ORIGINAL SPARTAN CHASSIS, INC.

CSB05-230-003A

CAMPAIGN SERVICE BULLETIN

SUBJECT: Radiator - Hardware

TITLE
RADIATOR
HARDWARE REPLACEMENT
KIT /INSTRUCTION

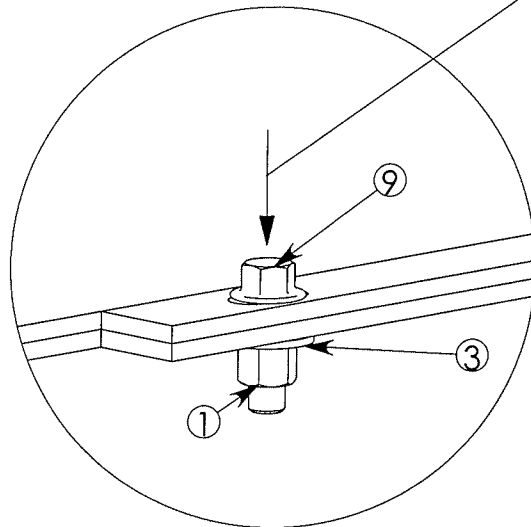
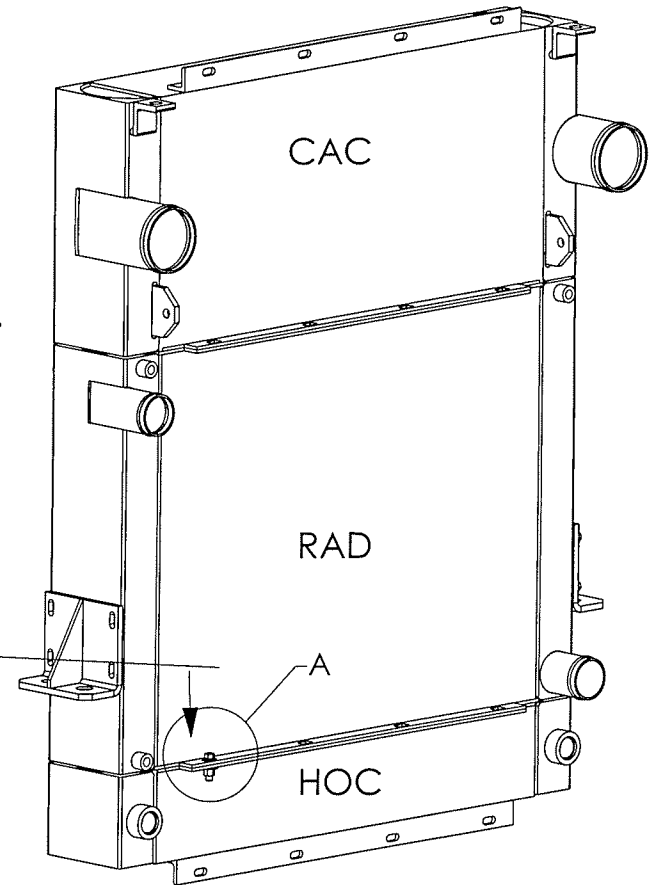
1. FAN SHOULD BE REMOVED FROM FAN DRIVE BEFORE REMOVAL OR REPLACEMENT OF RADIATOR BOLTS ON FAN/FAN SHROUD SIDE.
2. INSTALL NEW FLANGE BOLTS (3/8"-16 X 1 1/4" LONG), 3/8" WASHER AND NYLOC NUT AS SHOWN IN DETAIL "A"
3. TORQUE NUTS PER GRADE 5 SPECIFICATION 22 FT-LBS OR 264 IN-LBS
4. RE-INSTALL FAN ON FAN DRIVE PER INSTRUCTIONS ON PAGE 2 OF THIS KIT

TITLE
HARDWARE REPLACEMENT

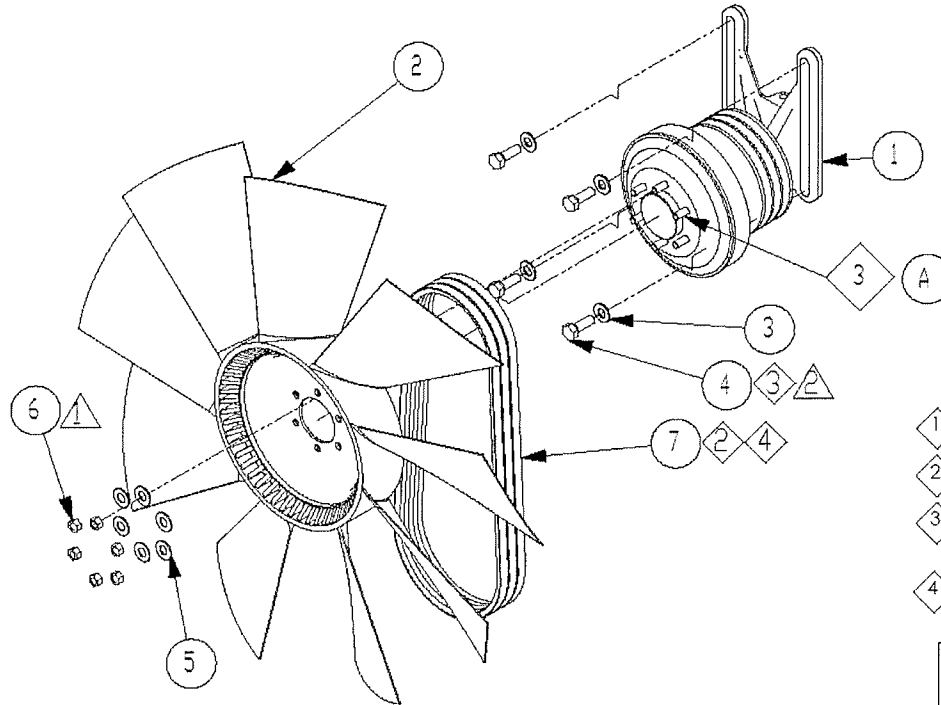
REV.	DESCRIPTION	AUTH	DATE	DR	CHK	APVD
A	ADDED THREAD ADHESIVE NOTE	F4412-B	10/05/05	AMS	SAM	MPB

- ◇ 1 USE ON 2002 SERIES 60 ENGINES
- ◇ 2 BELTS TO BE A MATCHED SET
- ◇ 3 APPLY 81790 ADHESIVE - REMOVEABLE THREAD LOCKER (BLUE) OR EQUIVALET.
- ◇ 4 60-80 LBS (NEW/USED)
